CONCEPT PLAN

WHIP CLEAN
CITY OF GAITHERSBURG
MONTGOMERY COUNTY, MARYLAND

SP-8819-2021 Initial Plan- Staff Comments

Planning Staff Comments

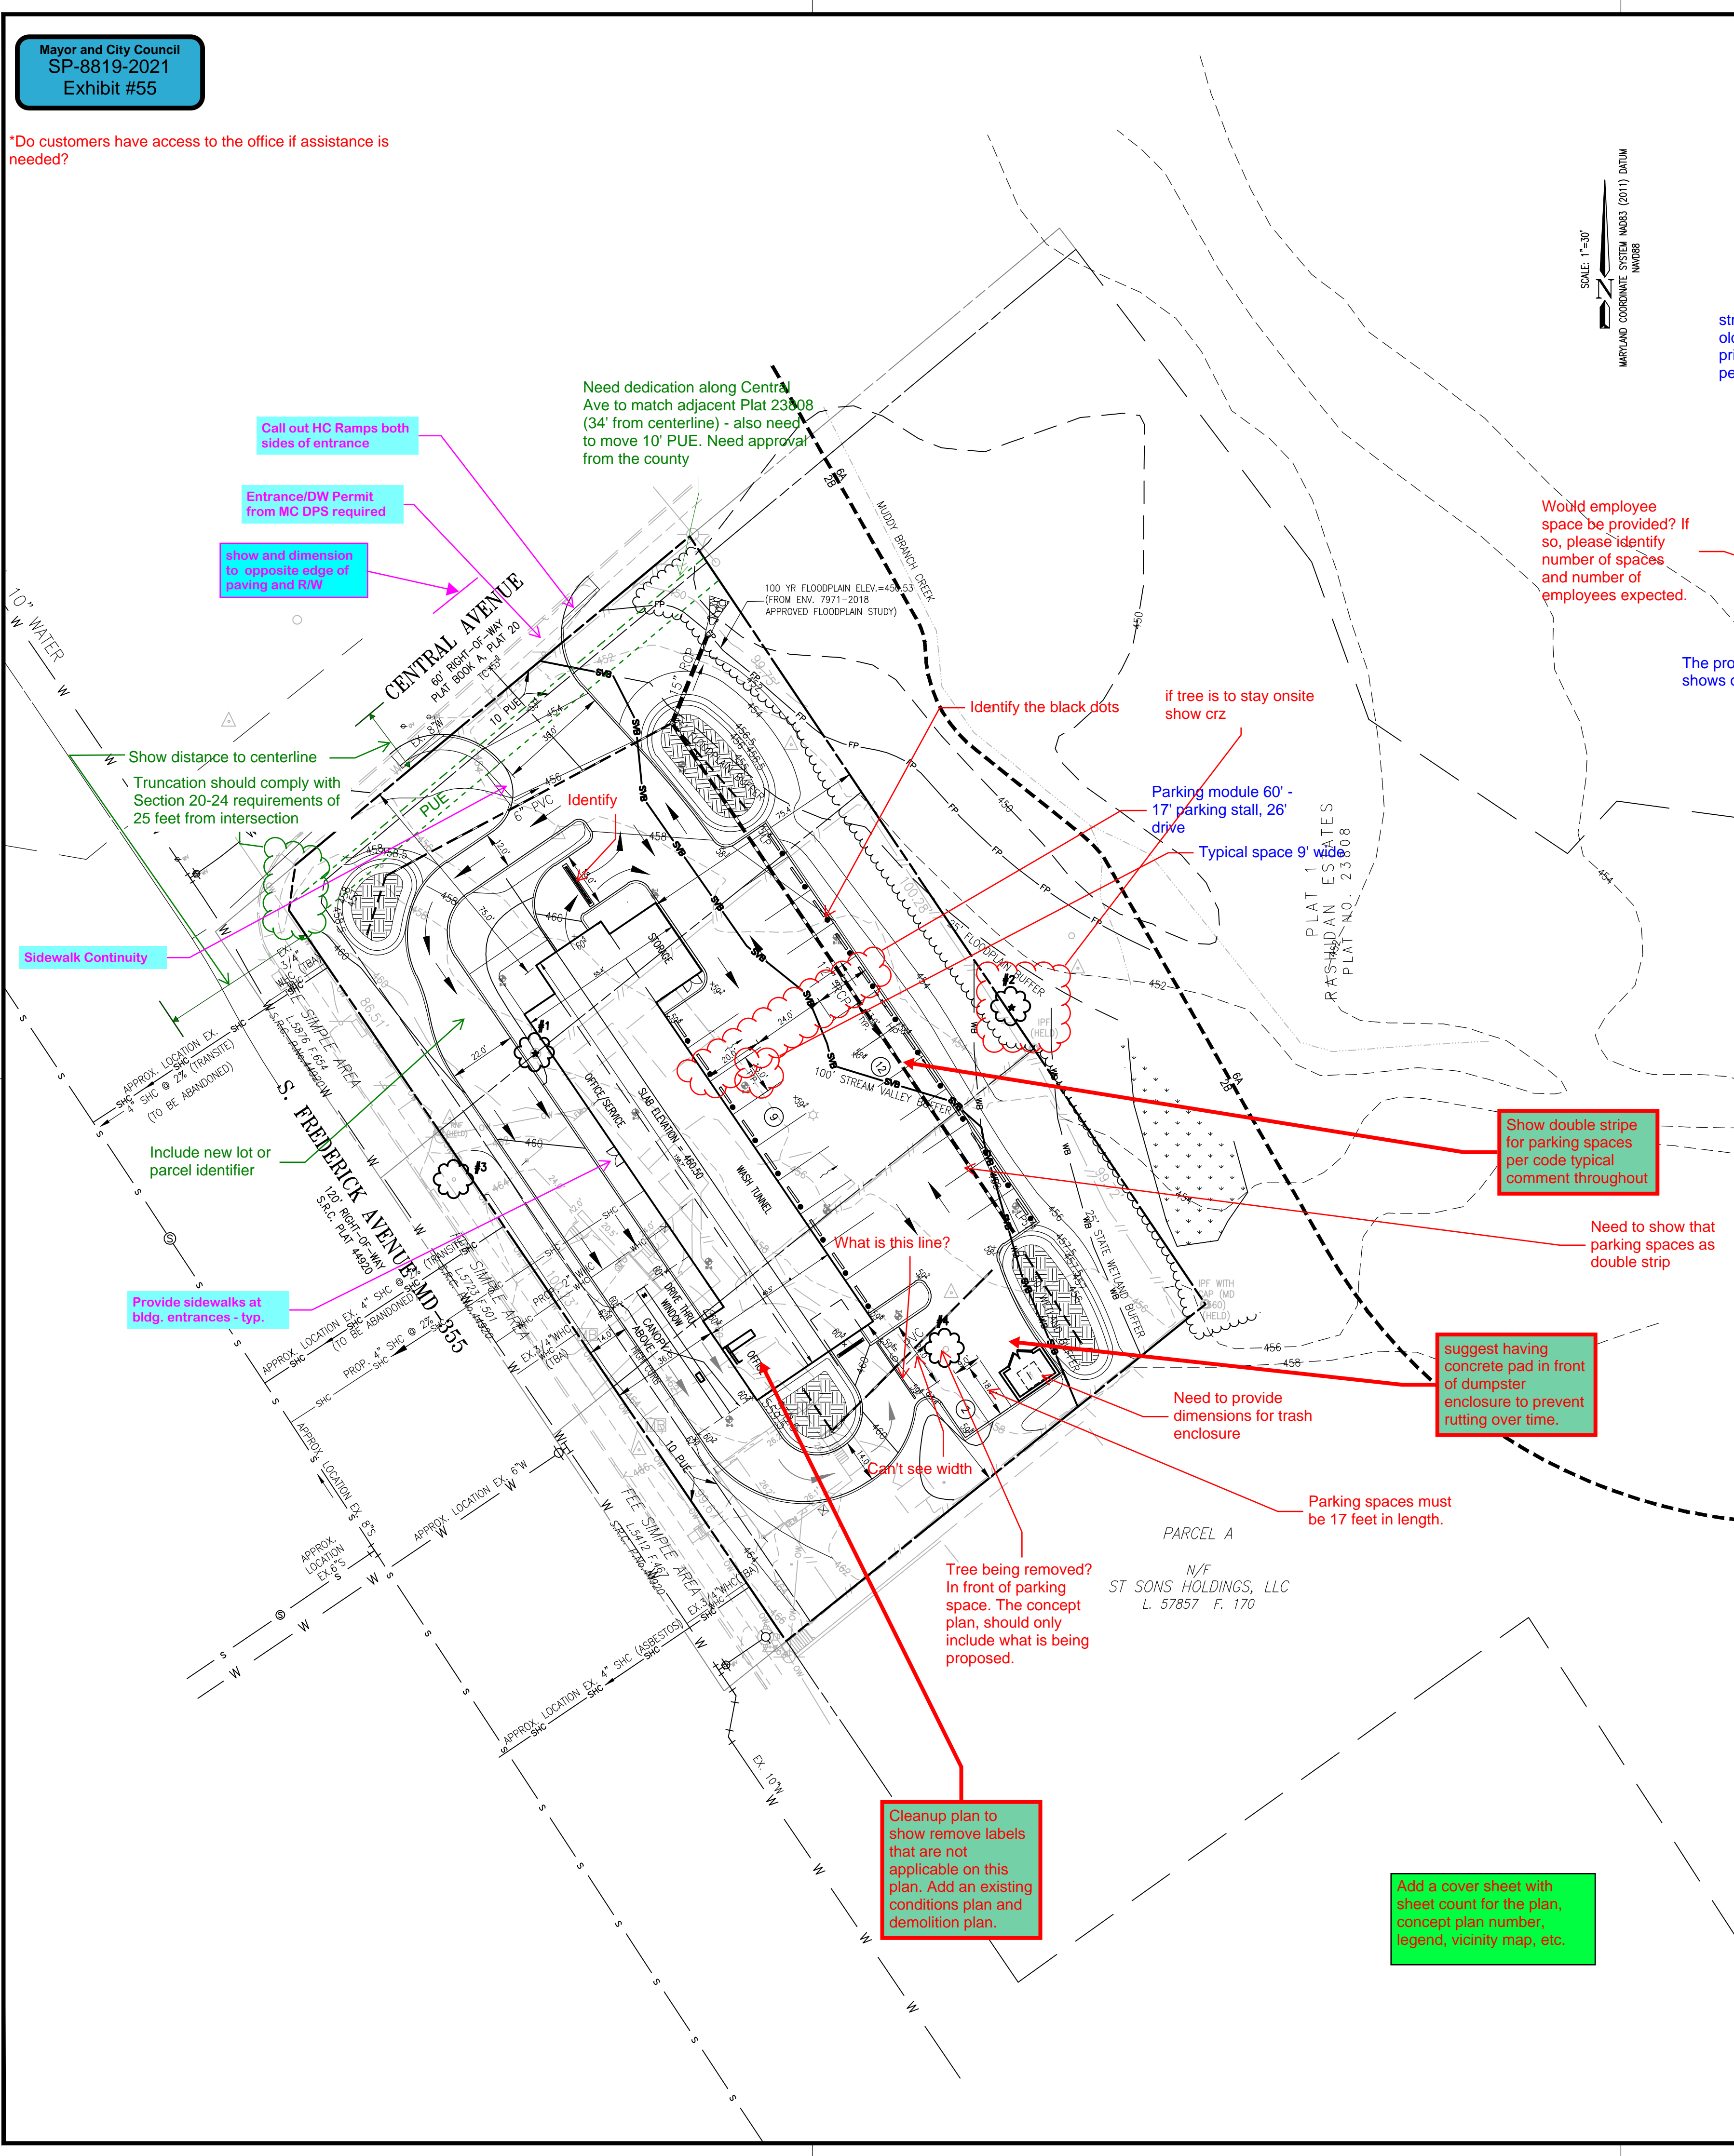
*Do customers have access to the office if assistance is needed?

- What is the line near the drive tunnel entrance?
- Provide a conceptual plan and conceptual utility plan
- Need to provide a separate existing plan sheet
- Waiver will need to be requested for the number of spaces, parking space dimensions and drive aisle dimensions

- Need to provide square feet of green space provided on the property
- Need to provide a minimum of ten percent of surface parking lot areas shall be devoted to planting area and/or environmental site design for stormwater management. Please identify percentage.

- Project has one bay, how did you determine that number
- Need handicap parking
- Note #8: Change note to state: "Structures over 50 years old require review by HDC prior to issuance of a demo permit.

- Would employee spaces be provided? If so, please provide the estimated number of spaces and the number of employees expected.
- Parking module must be 60 feet. Parking stall must be 17 feet in length, drive aisle must be 26 feet.

- If tree is to stay onsite, show critical root zone.
- Need dedication along Central Avenue to match adjacent Plat 23808 (34' from centerline). Also need to move 10' PUE

- Identify black dots
- Identify drain
- Show distance to centerline
- Truncation should comply with Section 20-24 requirements of 25 feet from intersection

- Include new lot or parcel identifier.
- Can't see drive aisle width
- Tree in parking lot being removed in the front of parking space. Remove the tree from the plans.

- Do customers have access to the office, if assistance is needed?
- Show parking spaces as double stripe

DRAFT FOREST CONSERVATION PLAN

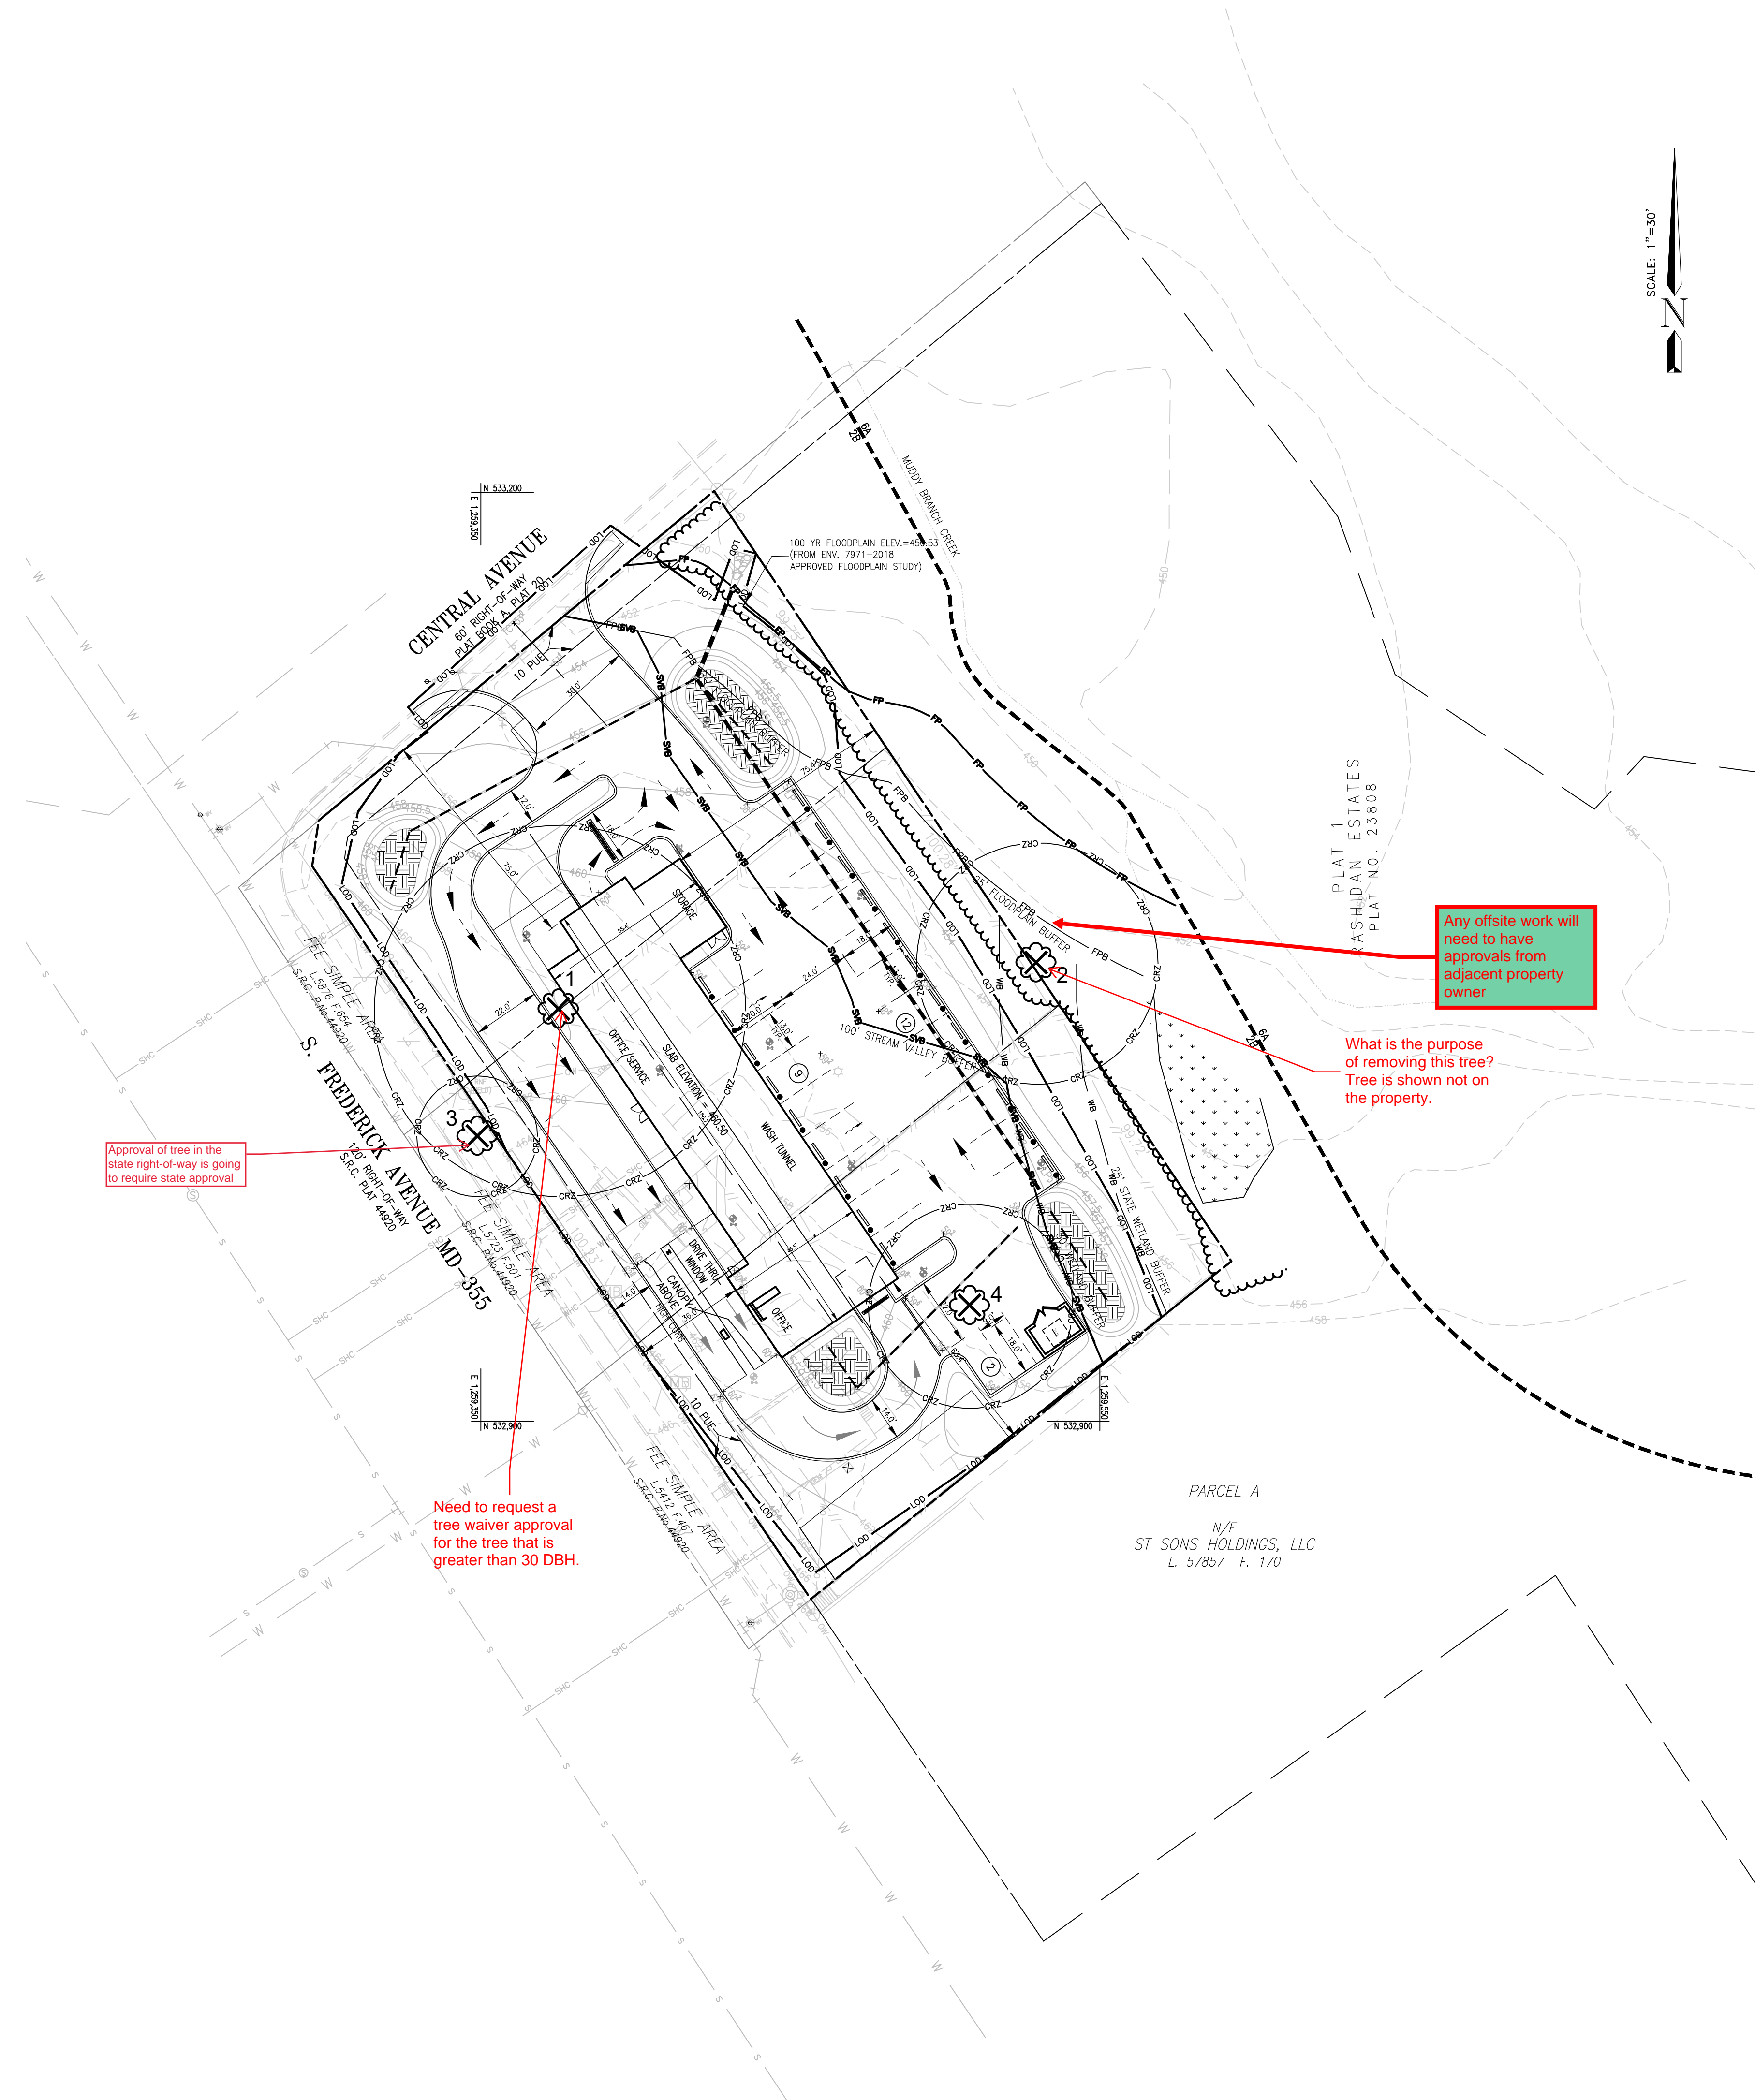
Name this sheet
Conceptual Forest
Conservation Plan

- Need to request a tree waiver approval for the tree that is greater than 30 DBH. Must be done during the concept site plan process.
- What is the purpose of removing tree #2? Tree is not on the property.
- Name this sheet as Conceptual Forest Conservation Plan
- Approval of tree in the state right-of-way is going to require state approval

DRAFT FOREST CONSERVATION PLAN

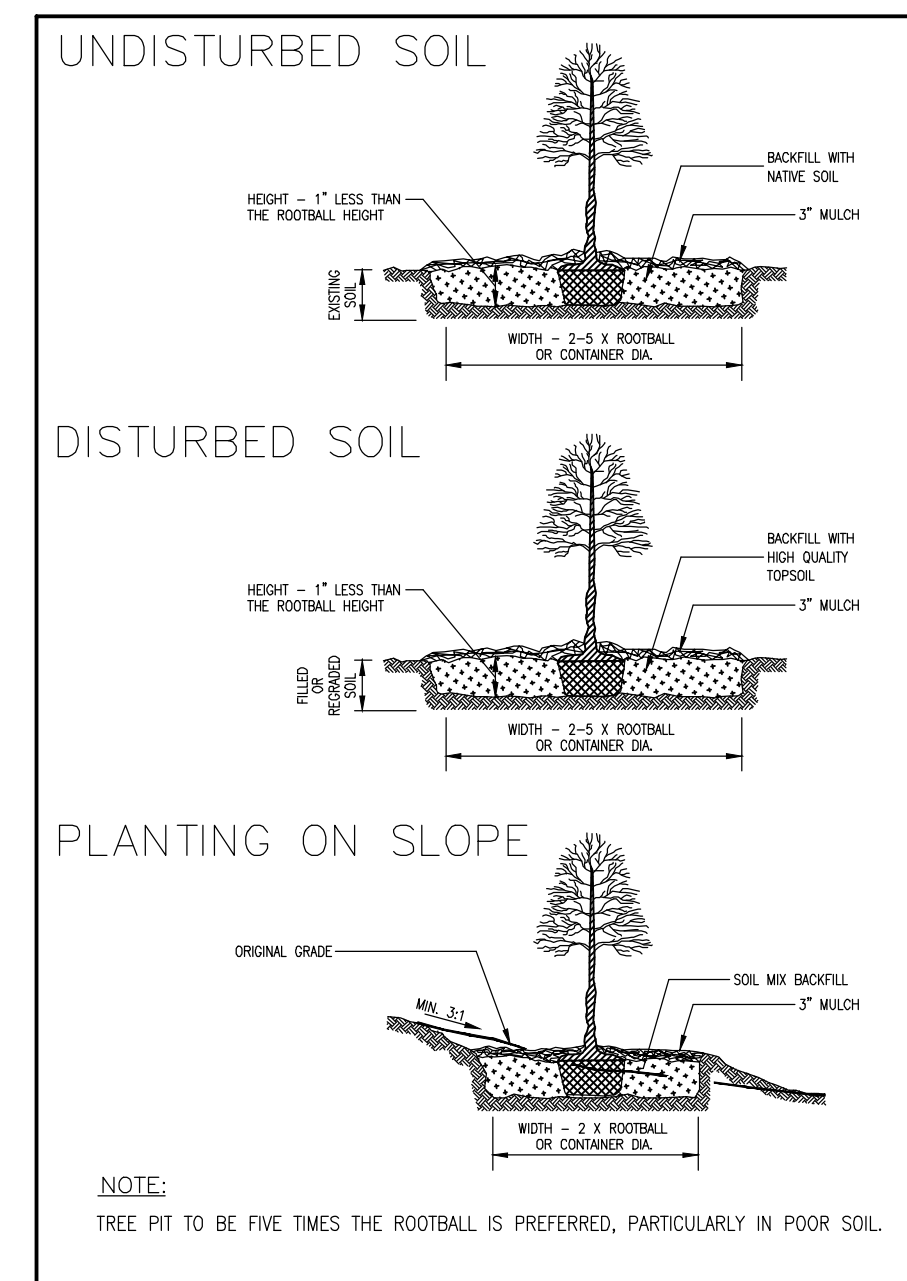
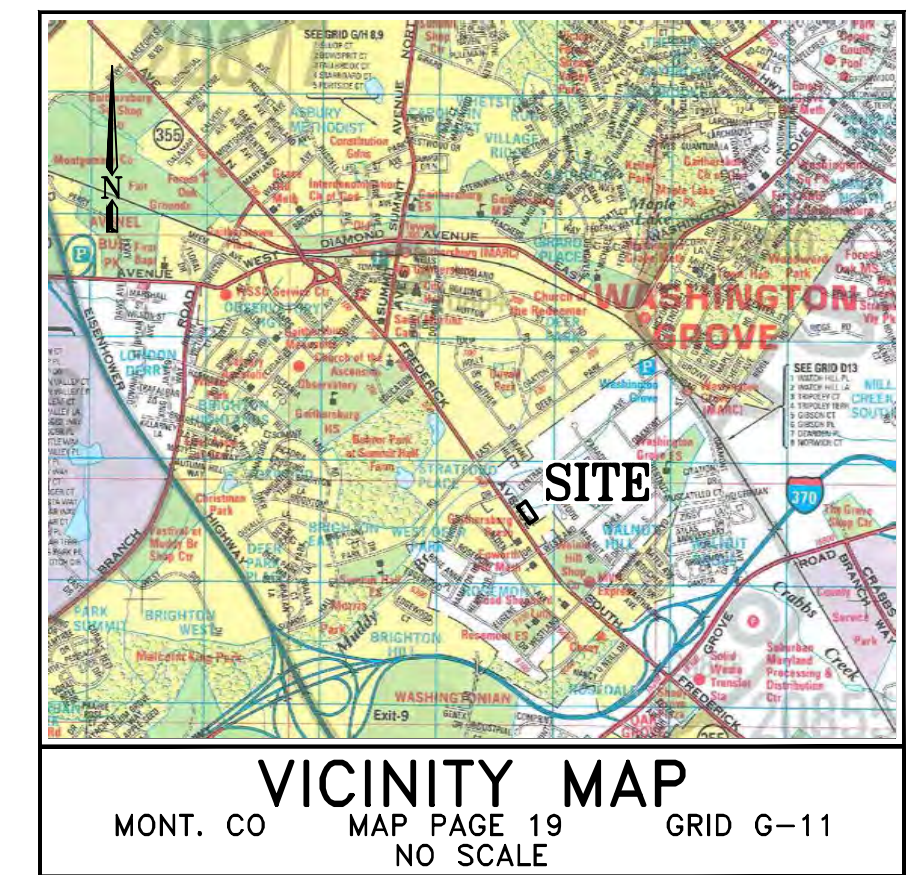
Remove this sheet
Conceptual Forest
Conservation Plan

- Name this sheet as Conceptual Forest Conservation Plan
